Author Comment with regard to:

Comparison of two closed-path cavity based spectrometers for measuring
air-water CO₂ and CH₄ fluxes by eddy covariance

by M. Yang et al.

26 October, 2016

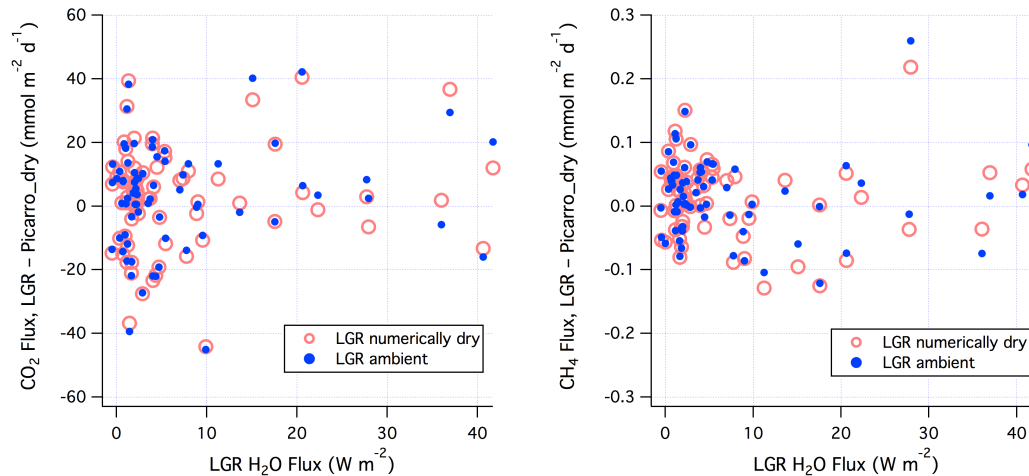
Page 7, lines 15–17 "Since the gas fluxes were computed using the same wind data and the two analyzers were sampling the same gas stream, differences between them are primarily caused by noise in the instruments, rather than by the presence of water vapor." :

Based on the evidence provided I cannot follow this conclusion. It might well be that the relatively small H₂O cross sensitivity corrections, which are applied by the LGR, are insufficient. See also the next comment on Figure 5.

We made this statement because the LGR fluxes (wet) and the Picarro fluxes (physically dried) are similar in the mean. The LGR fluxes (wet and numerically dried) show greater scatter, which is primarily due to noise in the LGR instrument rather than any corrections for water vapor. To be more specific, we have changed the second part of the sentence to "...hour to hour differences between them are primarily...."

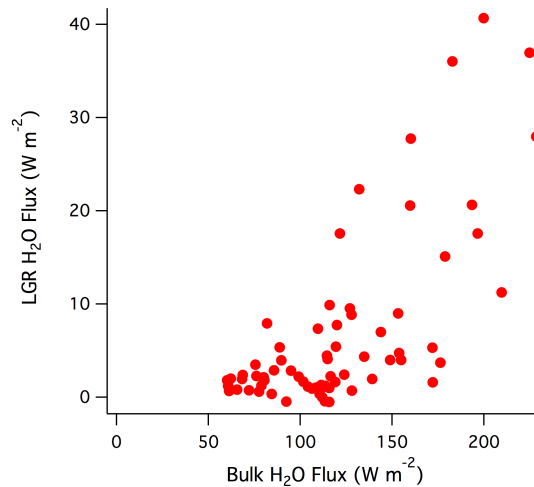
Page 7, lines 18–23 and Figure 5.: If the differences in the CH₄ and CO₂ measurements from the LGR (wet) and Picarro (dry) are caused by cross sensitivity of the LGR signals to H₂O one would expect a correlation with the latent heat flux measured by the LGR, but not necessarily with the predicted latent heat flux (the authors stated large and variable losses in the H₂O flux signal measured by the LGR). I would therefore suggest

to use the Latent heat flux measured by the LGR, instead of the predicted flux, as independent variable in Figure 5. The difference in the CO₂ fluxes measured by the two instruments should also be plotted as function of the latent heat flux measured by the LGR.

Thanks a lot for the comment. The plots below show what the referee had suggested. The LGR H₂O flux is computed at the optimal lag time for H₂O (~20s). The same qualitative trend is seen as in Fig. 5, i.e. the differences in CO₂ and CH₄ fluxes due to the H₂O correction increase with increasing H₂O flux. Also, the equivalent of the current Fig. 5 for CO₂ illustrates a similar pattern to CH₄, which is why we didn't show it in the current manuscript.

We did not include these plots in the paper because the measured LGR H₂O flux was severely attenuated by the tubing and its actual magnitude in W/m² is probably not especially informative for other users/translatable to other setup. The following plot shows that measured LGR H₂O flux increases non-linearly with bulk H₂O flux. We will add these plots to supplementary materials.

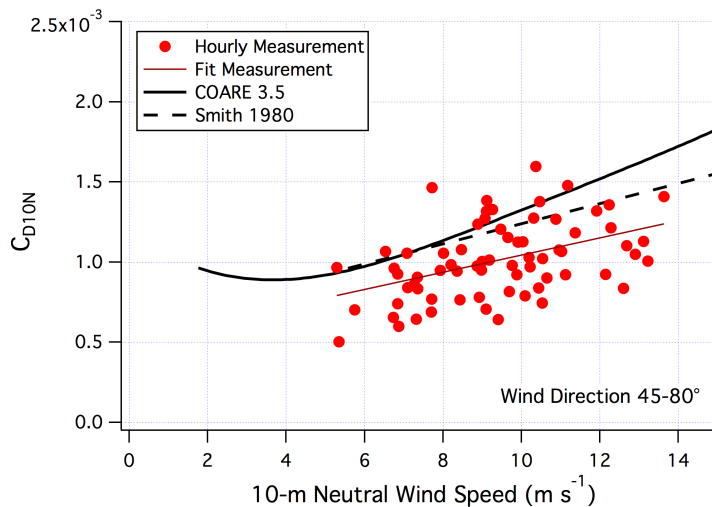
Page 12, lines 24–27 and Figure A2: I would suggest to add a trend line to the data shown in Figure A2. To me the difference in the drag coefficients looks more like 30% of the CORARE 3.5 drag coefficient.

Suggestion accepted. Please see below. The apparent underestimation of the measurement is ~15% at low wind speeds and ~30% at the highest wind speed. This is probably due to flow distortion by the local topography (i.e. mostly speeding up of horizontal wind), which we have not accounted for.
